# AUSTIN

## JOURNAL

C A R S  
VOLUME 24

New arrangement STR 1282

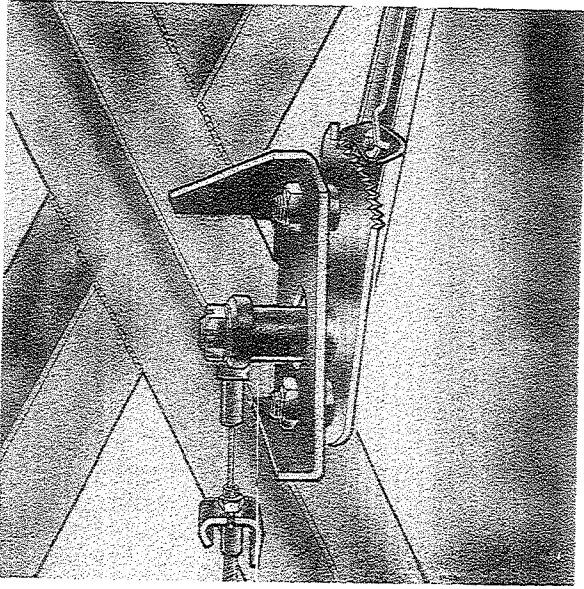
The new handbrake assembly, together with the longer screws and the distance pieces, can be used to replace the old one. The handbrake lever ratchet plates are not interchangeable.

# FULL FLOW OIL FILTER

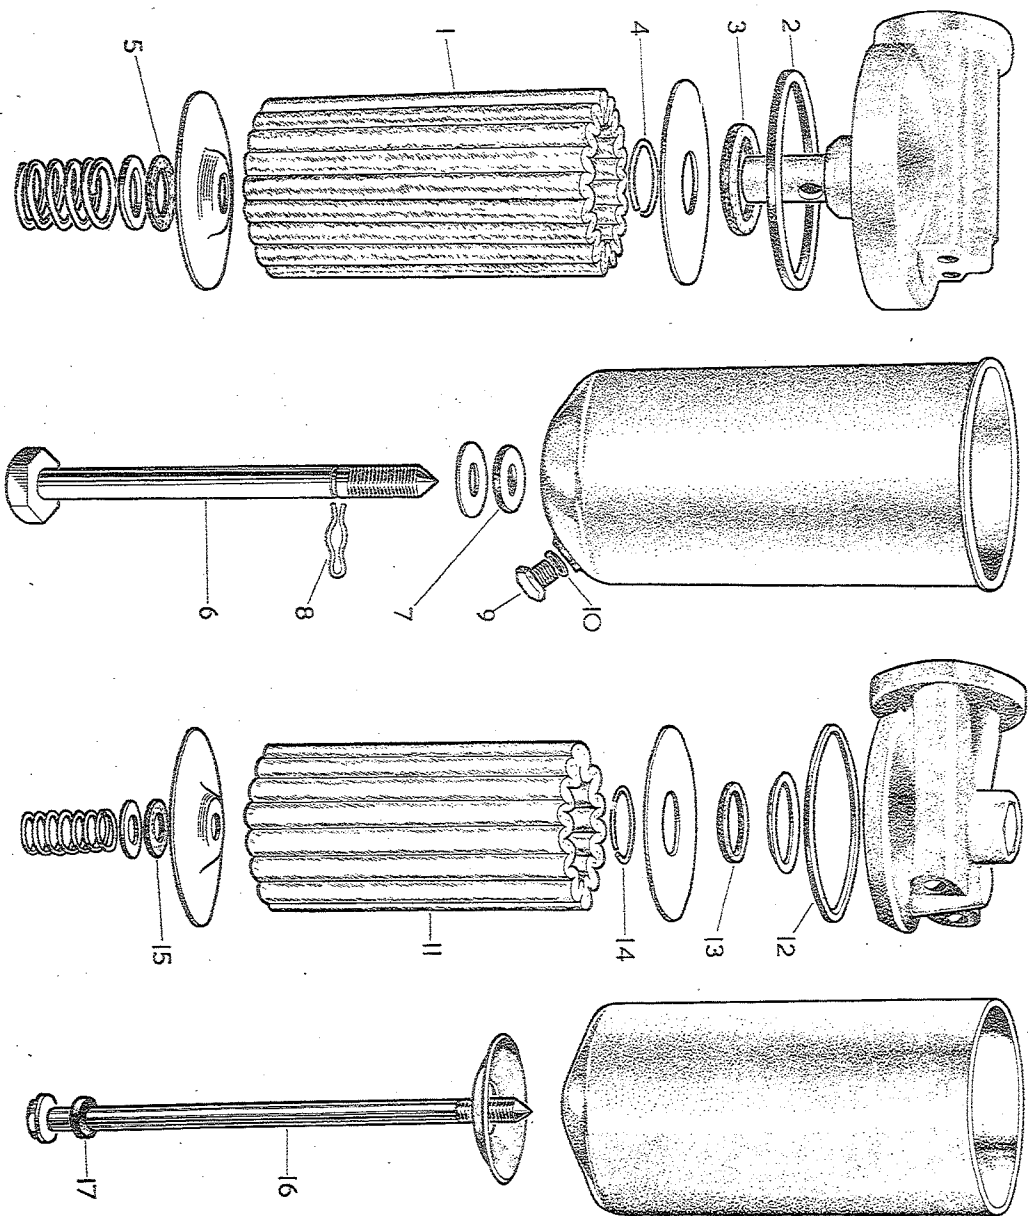
The Tecalemit oil filter (which is an alternative to the Purolator one) has been redesigned to facilitate manufacture. The new filter works in exactly the same way as the old one, but the component parts have been modified, with the exception of the filtering element which has not been altered—see illustration.

Fig. 1

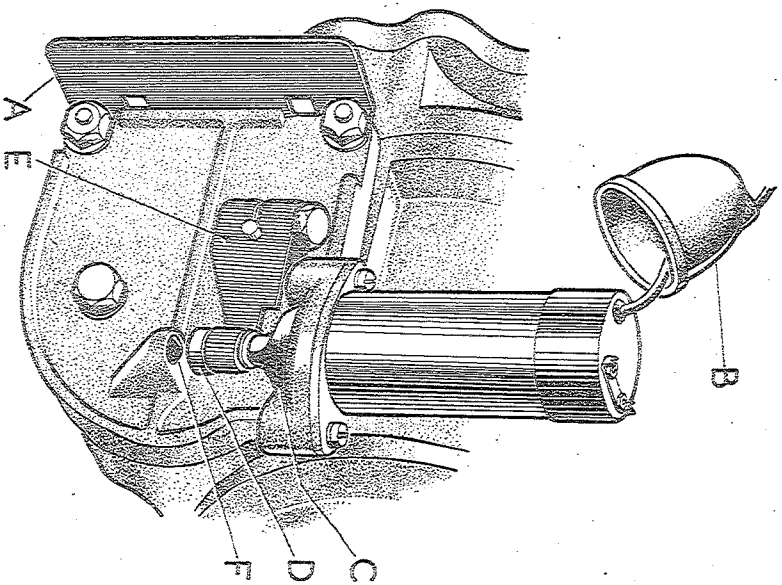
have also been modified and the plunger now has a rubber stop F in place of an adjusting bolt. INTERCHANGEABILITY  
The old and the new parts are not interchangeable. The overdrive assembly is interchangeable and the part number remains unchanged.

Fig. 2

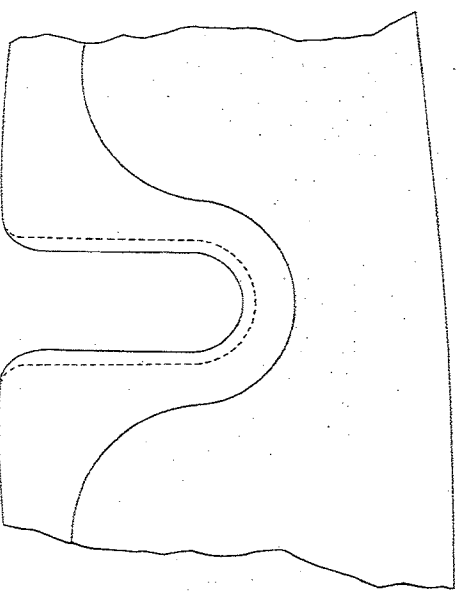
To preserve a neat appearance the width of the cut-out in the facia panel for the steering column has been reduced from  $2\frac{1}{4}$ " (57.15 mm.), as shown by the dotted line, to  $1\frac{3}{8}$ " (44.45 mm.)—see Fig. 2.

Fig. 3

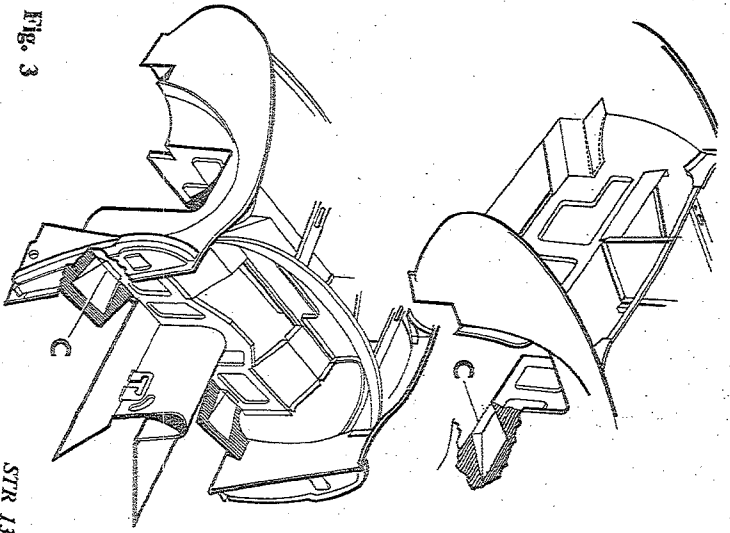
The extra height of the new spring has necessitated modifications to the body to give sufficient clearance between the top of spring and the body when the spring is in the full bump position. The top of the rear spring shackle box has been raised by 1 $\frac{1}{4}$ " (31.749 mm.) at its front end, as shown by the dotted line B which marks the position of the original top—see Fig. 2. At the front end of the rear spring the floor panel has been raised at C by  $\frac{3}{4}$ " (19.05 mm.) immediately above the shackle—see Fig. 3.

The new springs cannot be fitted unless the body is modified to give sufficient clearance at
